RENESAS TECHNICAL UPDATE

Product Category	MPU/MCU		Document No.	TN-RZ*-A023A/E	Rev.	1.00
Title	Additional explanation for EthernetAVB of RZ/G Series		Information Category	Technical Notification		
Applicable Product	RZ/G Series RZ/G1H, M, N and E	Lot No.	Reference Document	RZ/G Series User's Manual: Hardware Rev.1.00 (R01UH0543EJ0100)		
		All lots

RZ/G Series User's manual: hardware correction for EthernetAVB.

37A.2.39 Interrupt Summary Status Register (ISS)

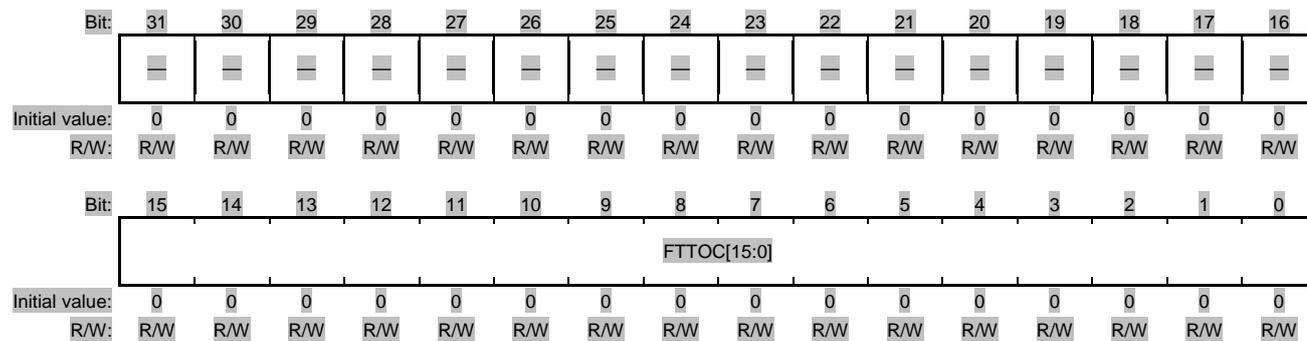
Correction (to):

Bit:	31	30	29	28	27	26	25	24	23	22	21	20	19	18	17	16
	DPS15	DPS14	DPS13	DPS12	DPS11	DPS10	DPS9	DPS8	DPS7	DPS6	DPS5	DPS4	DPS3	DPS2	DPS1	—
Initial value:	0	0	0	0	0	0	0	0	0	0	0	0	0	0	0	0
R/W:	R	R	R	R	R	R	R	R	R	R	R	R	R	R	R	R
Bit:	15	14	13	12	11	10	9	8	7	6	5	4	3	2	1	0
	—	—	CGIS	RFWS	—	—	TFWS	TFUS	MS	ES	—	—	—	FTS	—	FRS
Initial value:	0	0	0	0	0	0	0	0	0	0	0	0	0	0	0	0
R/W:	R	R	R	R	R	R	R	R	R	R	R	R	R	R	R	R

Bit	Bit Name	Initial Value	R/W	Description
9	TFWS	0	R	<p>Time Stamp FIFO Warning Interrupt Summary</p> <p>This bit is set to 1 when the time stamp FIFO warning interrupt enable bit (TIC.TFWE) and time stamp FIFO warning interrupt status flag (TIS.TFWF) are both 1.</p> <p>0: The interrupt is not pending. 1: The interrupt is pending.</p>
8	TFUS	0	R	<p>Time Stamp FIFO Update Interrupt</p> <p>This bit is set to 1 when the time stamp FIFO update interrupt enable bit (TIC.TFUE) and time stamp FIFO update interrupt status flag (TIS.TFUF) are both 1.</p> <p>0: The interrupt is not pending. 1: The interrupt is pending.</p>
7	MS	0	R	<p>E-MAC Interrupt Summary</p> <p>This bit is set to 1 when an E-MAC interrupt is issued.</p> <p>0: The interrupt is not pending. 1: The interrupt is pending.</p>
6	ES	0	R	<p>Error Interrupt Summary</p> <p>This bit is set to 1 when an error interrupt is issued (both of a bit in EIS and corresponding to the bit in EIC are 1).</p> <p>0: The interrupt is not pending. 1: The interrupt is pending.</p>

5 to 3	—	All 0	R	<p>Reserved</p> <p>These bits are read as 0.</p>
2	FTS	0	R	<p>Frame Transmitted Summary</p> <p>[Changing condition]</p> <p>This bit is set when any matching pair of TIC.FTEt enable and TIS.FTFt flag are both 1b.</p> <p>0: No interrupt pending 1: Frame transmitted interrupt pending</p>
1	—	0	R	<p>Reserved</p> <p>These bits are read as 0.</p>
0	FRS	0	R	<p>Frame Received Summary</p> <p>[Changing condition]</p> <p>This bit is set when any matching pair of RIC0.FREr enable and RIS0.FRFr flag are both 1b.</p> <p>0: No interrupt pending 1: Frame received interrupt pending</p>
